**BRIDGE NO. 9**  
**PBU 1&2 PLAN**  
SCALE: 1"=10'

**PBU 1 & 2**  
**DETAILS**  
**BHF 0169(09)**  
**CHELSEA, VERMONT**

Vermont Agency of Transportation  
**RECEIVED**  
CK'D BY TYLin OK'D BY TYLin  
April 5, 2017  
RESUBMIT No Approved AsNoted  
BY Kristin Higgins DATE 4/7/2017

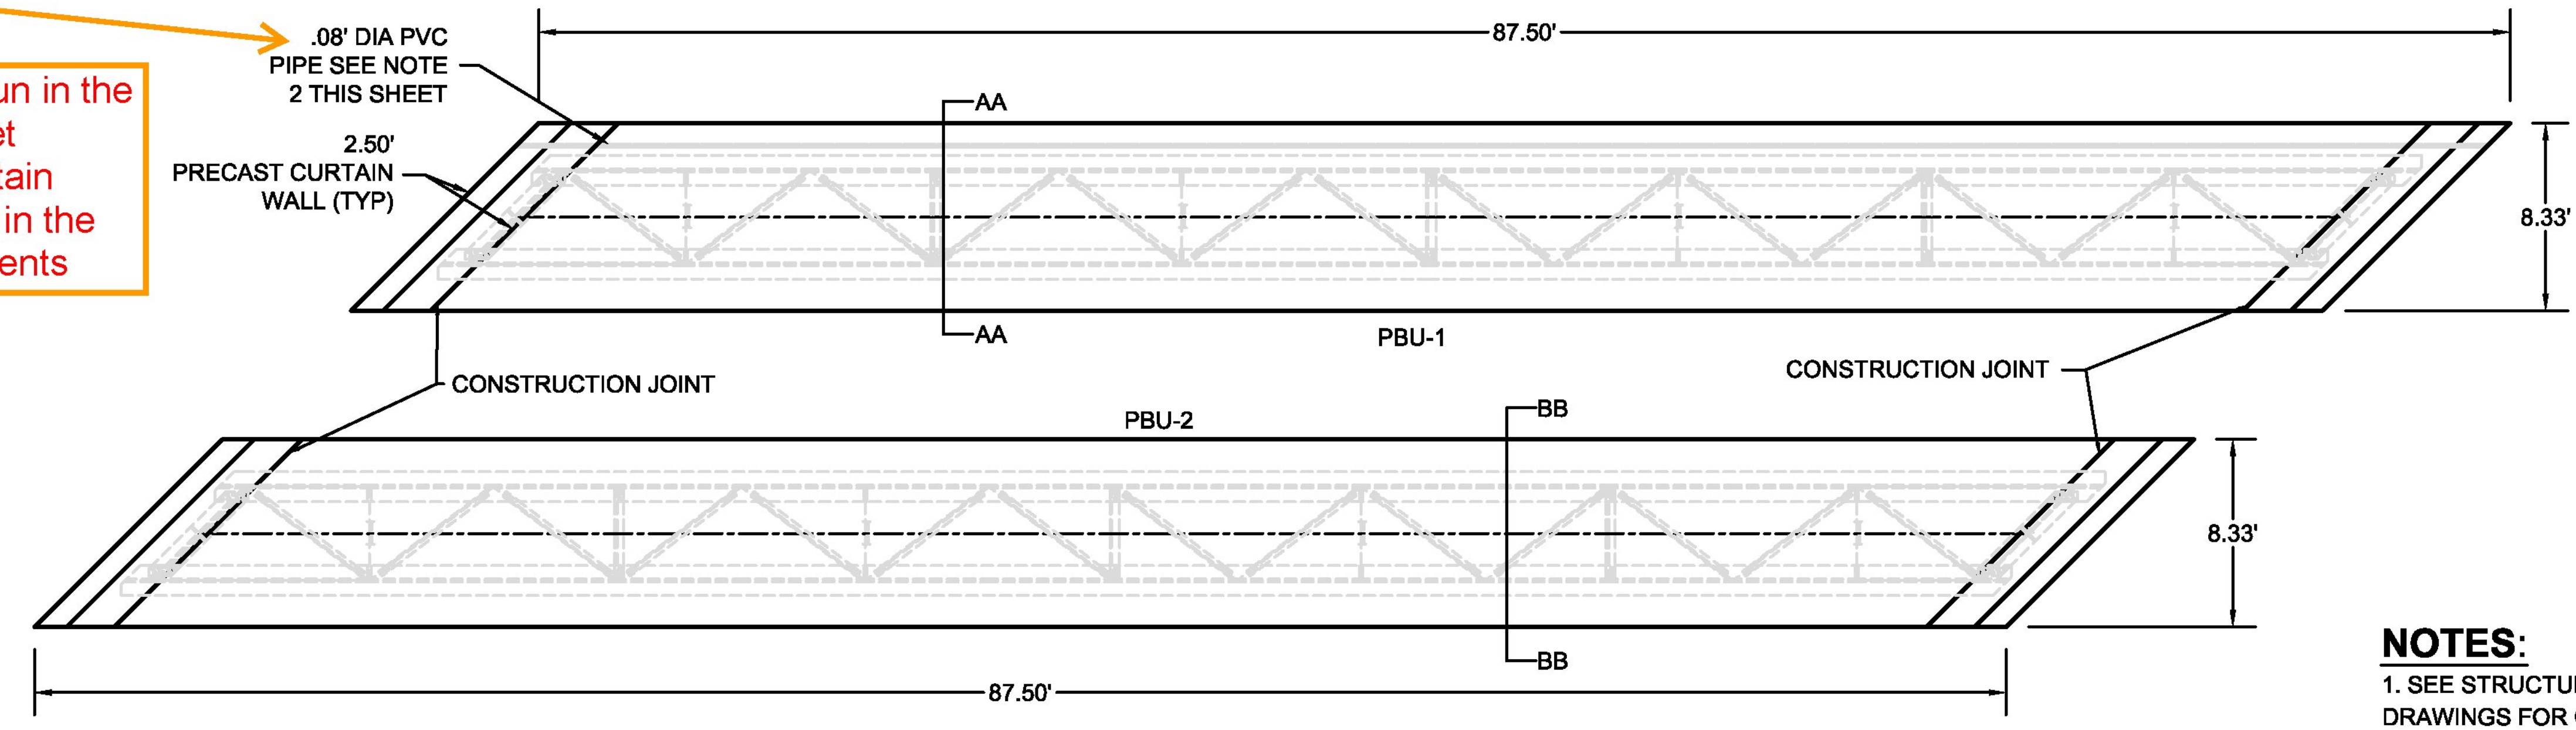
This needs to run in the railing and outlet through the curtain walls as shown in the contract documents

**PBU 1 SECTION "AA"**  
**N.T.S.**

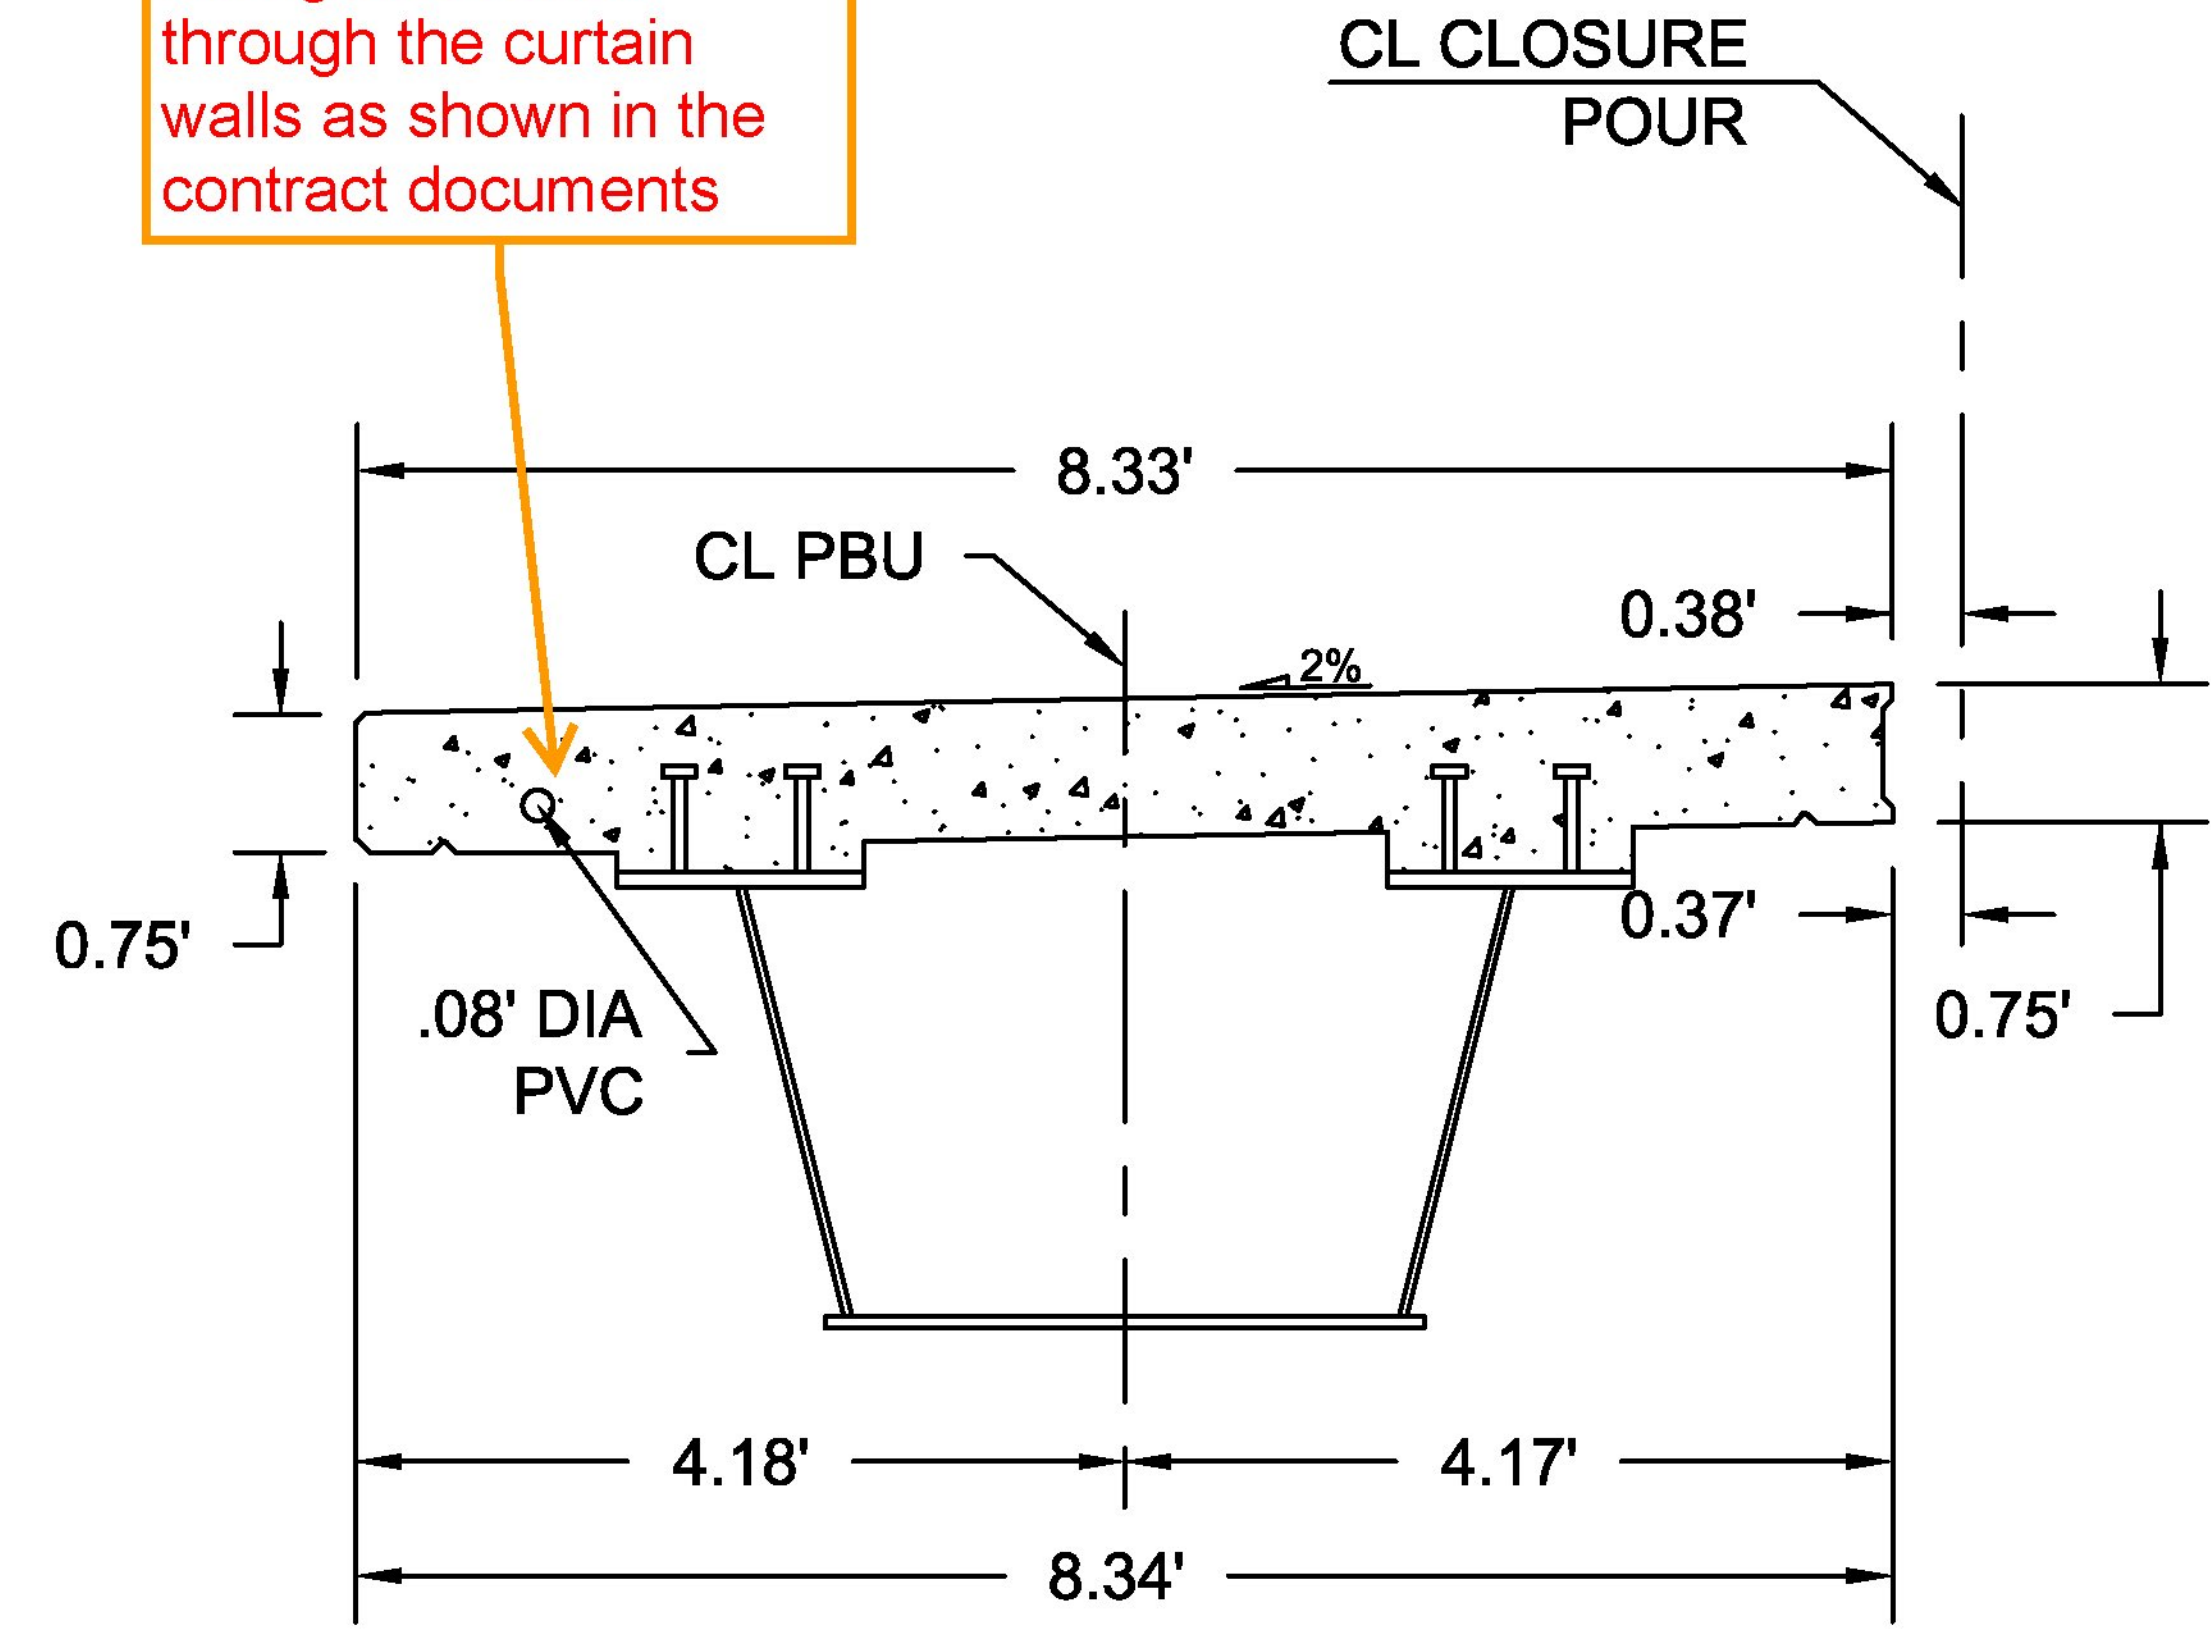
This needs to run in the railing and outlet through the curtain walls as shown in the contract documents
